Report to Planning and Environment Committee

Subject: 1150 Fanshawe Park Road East
File SPA21-050
Stackhouse Developments (London) Inc.

Date: Public Participation Meeting on September 20, 2021

Site Plan

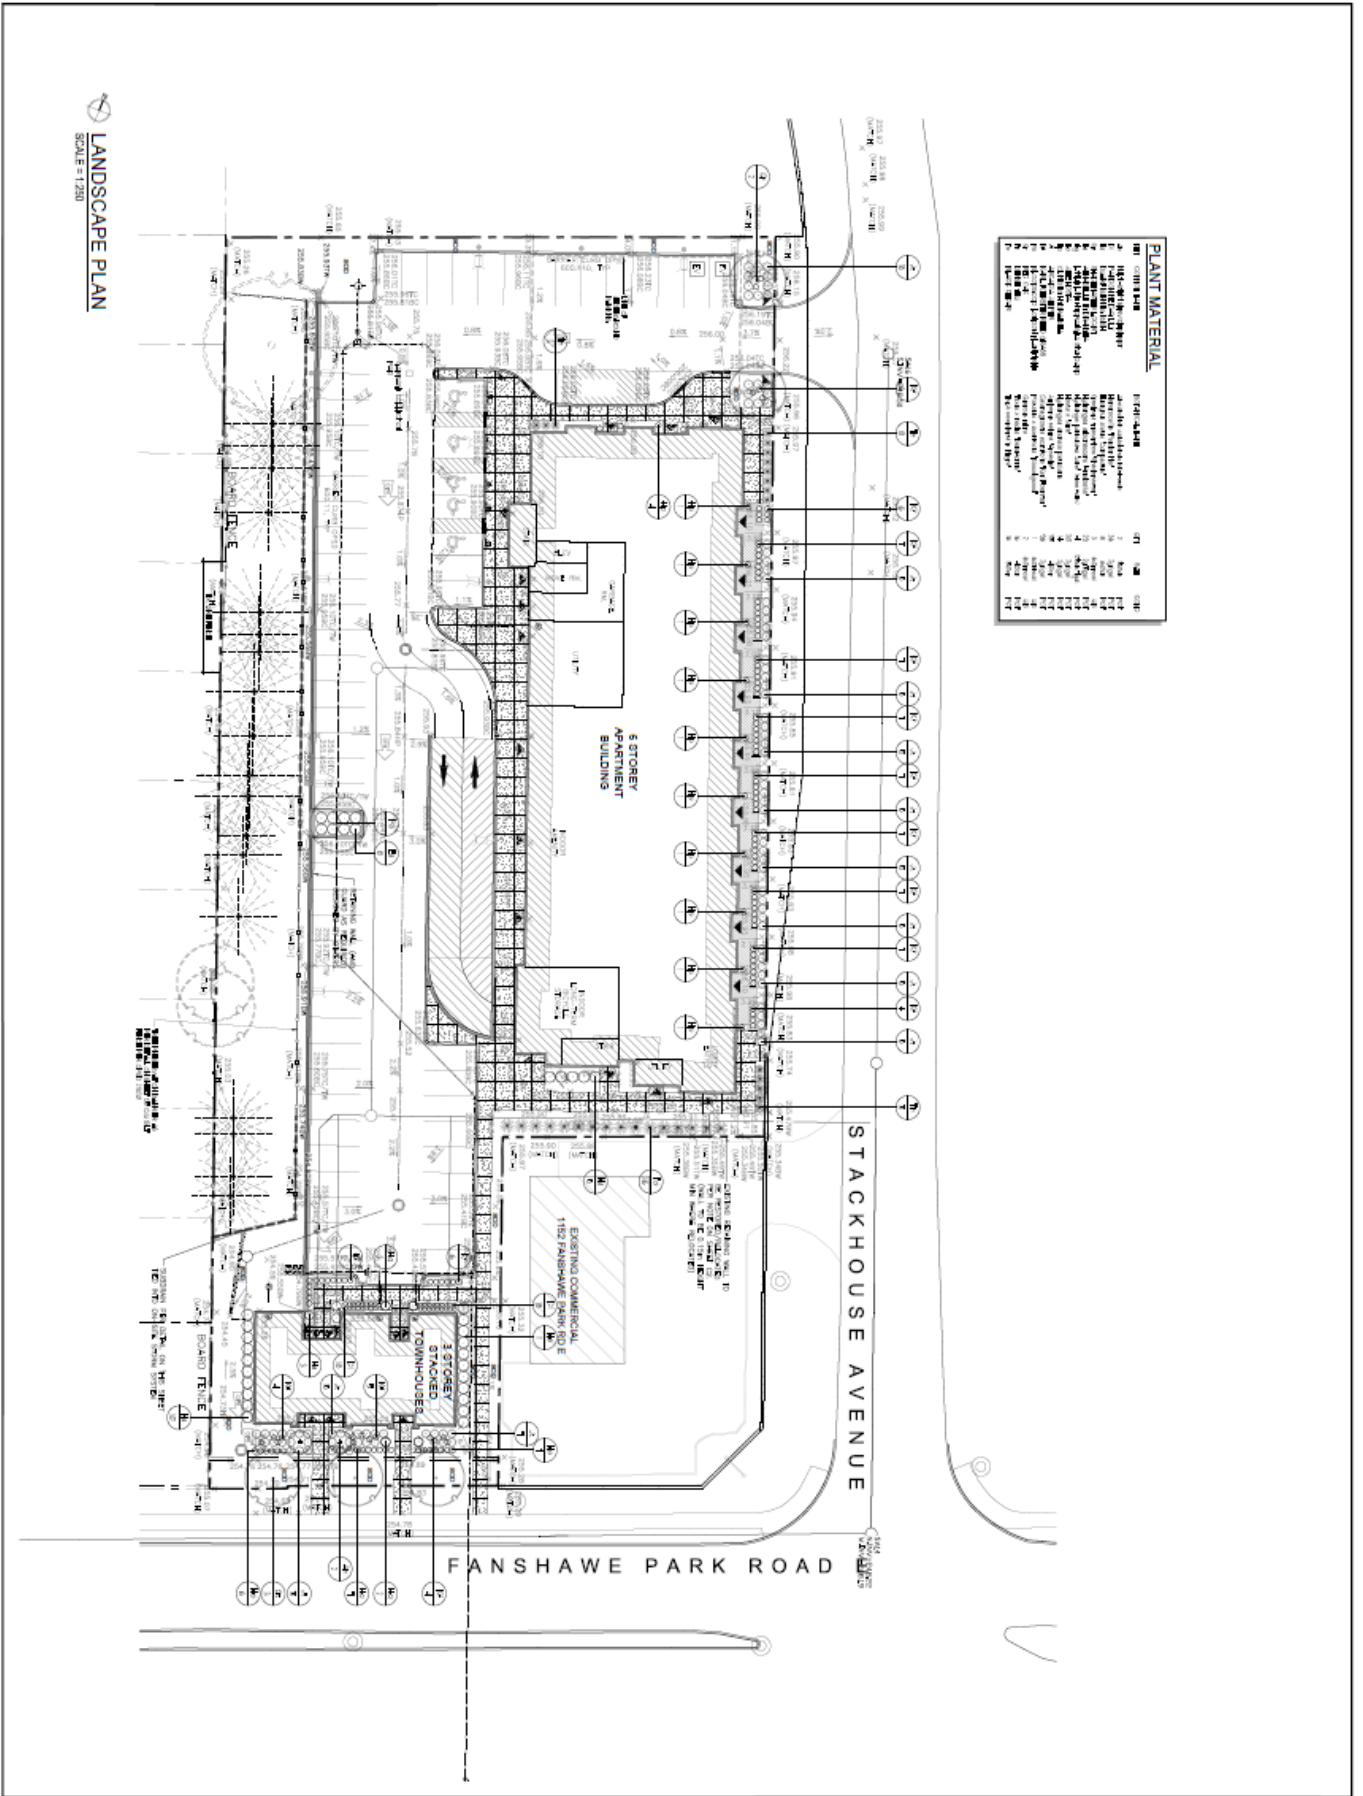
3. Identify the fire route sign numbers on the site plan.
4. Solid Waste requires further clarification on the intent of garbage pick-up for the stacked townhouse units as there is no space for a turn-around. Will the garbage be placed along Fanshawe Park Road West or brought to the garbage collection pad on pick-up day? Please clarify.

5. Confirm the height and location of the proposed board-on-board fence on the site plan.
6. The current proposed snow storage areas along the western property boundary require the snow to be piled behind the retaining wall. Consider alternative snow storage locations or explore opportunities for snow to be trucked off site. If the snow is proposed to be trucked off-site, please note this on the site plan.

7. Revise the underground parking configuration to revise the location of the storage lockers. Consider a more common location. The current configuration does not allow for direct access and the doors may impact the proposed parking stalls.

8. Revise the photometric plan to ensure there is a 0.0 rating of light cast along the northern property line.
9. Dimension the barrier-free parking stall lengths.

10. Revise the sidewalk width at the building frontage to be 1.8 metres to meet barrier-free requirements set out in the Accessibility Checklist.
11. Refer to Figure 6.4 of the Site Plan Control By-law for the appropriate fire route sign details. Update the site plan details page to include the correct fire route sign details.
